Class 2 permissive change justification Letter

hereby to do the class 2 permissive change application justification on FCC application: Smart Phone, VTR-L29, FCC ID: QISVTR-L29, granted data: 2017-02-15 as following:

Description of the change:

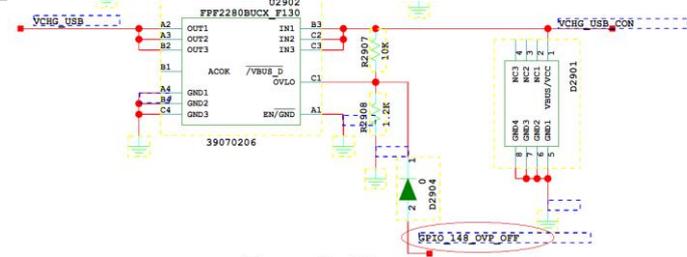
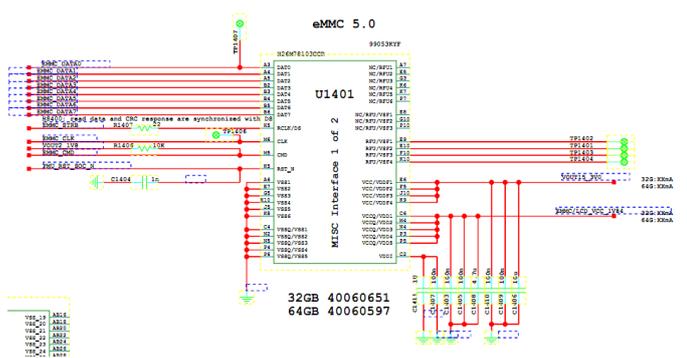
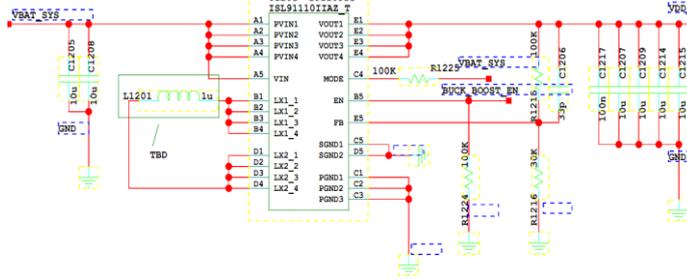
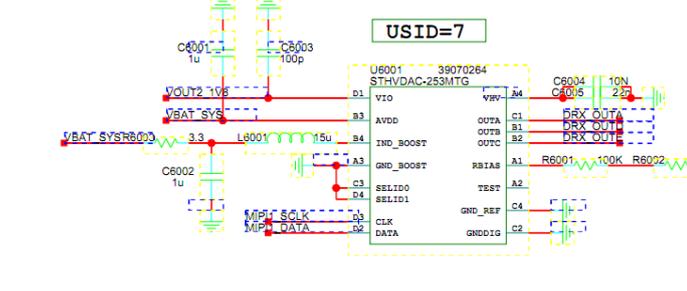
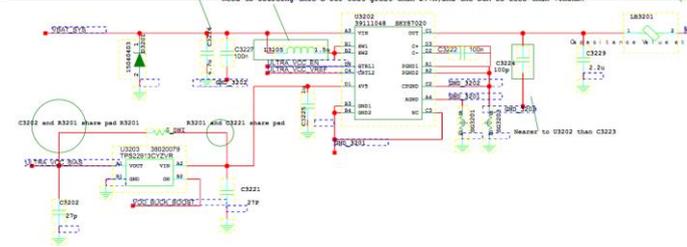
There three changed points:

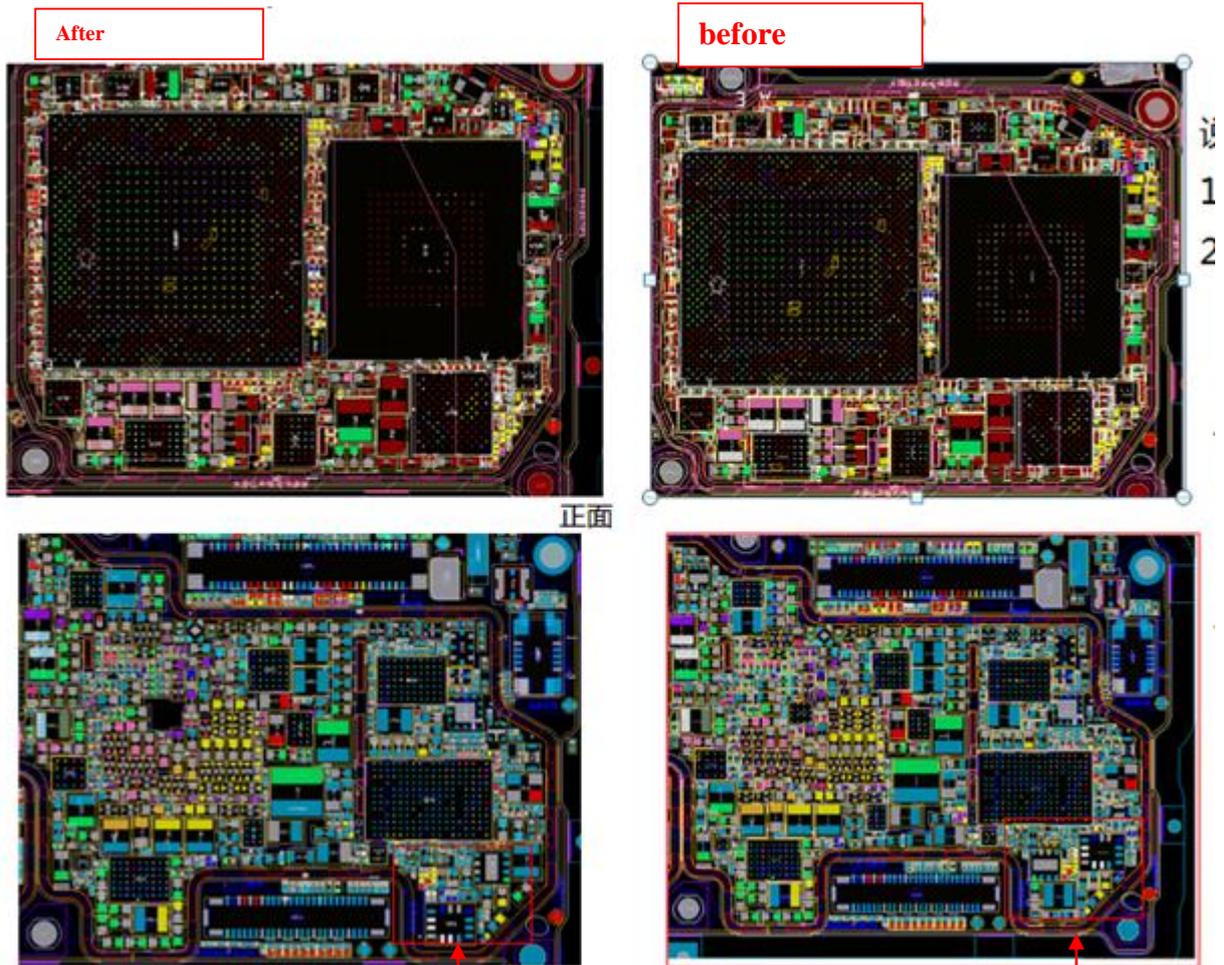
- 1) Add an alternate NAND FLASH and the related match circuit is changed as well.

Before	After
Memory type : UFS2.0 Description : Gear3 2lane RPMB 16MB@1key(G3-1lane 4MB RPMB for one exception),3.3V/1.8V,FBGA153b	Memory type : eMMC5.1 Description : CMDQ,400MHz,3.3V/1.8V,FBGA153

UFS change to EMMC,

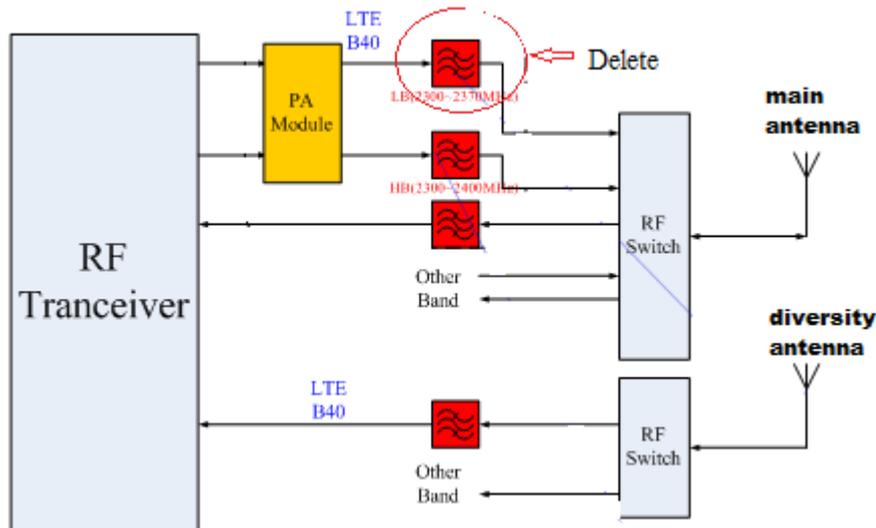
Change of match circuit as below:

After	Description
	<p>For UFS is changed to EMMC, the related power supply circuit is changed.</p>
	<p>For UFS is changed to EMMC, the related power supply circuit is changed.</p>
	<p>For UFS is changed to EMMC, the related interface circuit is changed.</p>
	<p>For UFS is changed to EMMC, BOOT_UFS pin is connected to GND.</p>
<p>NC</p>	<p>GPIO_033 pin is disused.</p>

<p>GPIO_148_OVP_OFF</p>	<p>buckboost_INT,GPIO_148 is changed to GPIO_148_OVP_OFF.</p>
	<p>The net OVP OFF changed to GPIO_148 from GPIO_033</p>
	<p>(1) UFS is changed to EMMC; (2) The name of the net GPIO_022 changed to GPIO_022_EMMCPOWER_INT_N</p>
	<p>BUCKBOOST is changed to a new device</p>
<p>NA</p>	<p>GPIO_108 is disused.</p>
	<p>Tuner IC is changed</p>
	<p>Add U3203's match circuit.</p>

- 1>. No change on front PCB layout
- 2>. Because the power supply circuit changed, so PCB layout on the lower right corner have some differences
- 3>. Performance is significantly lower
